SUNDRY NOTICES AND REPORTS ON WELLS

8. Well Name and No.
GREEN WAVE 20 32 FED STATE COM 8H

Devon Energy Production Company L.P. (Devon) respectfully requests approval to move the SHL for the Green Wave 20-32 State Fed Com 8H.

WELL LOCATION AND ACREAGE DEDICATION PLAT

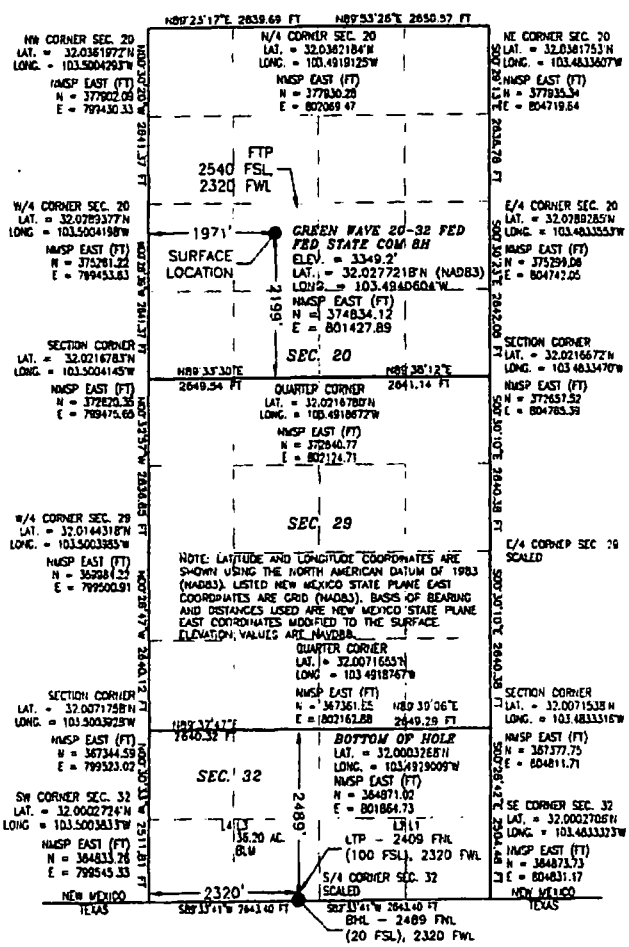
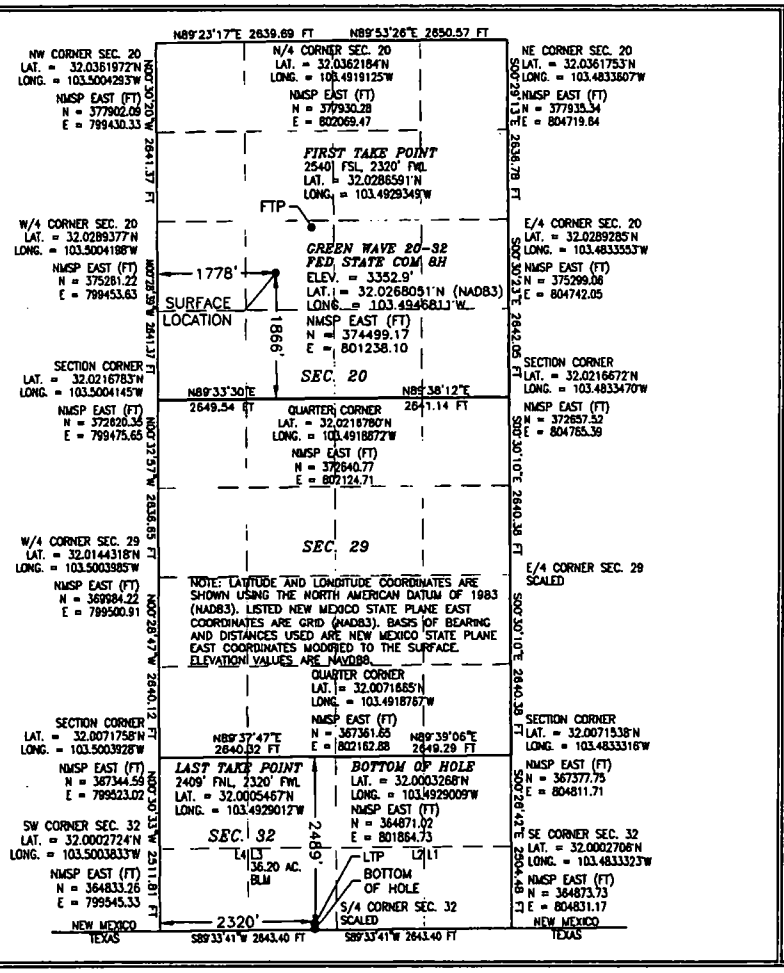
The reason for the SHL move is due to the original SHL being staked on an old buried reserve pit. Devon is concerned about the ground stability under the reserve pit.

Permitted SHL: NESW 2199 FSL, 1971 FWL, 20-26S-34E
Proposed SHL: NESW, 1866 FSL, 1778 FWL, 20-26S-34E

Please see attached revised C-102, old C-102, Drilling plan, Directional plan.

All disturbance will be entirely within 600 X 600 approved pad in Section 20, Township 26S Range 34E, Lea County, New Mexico.
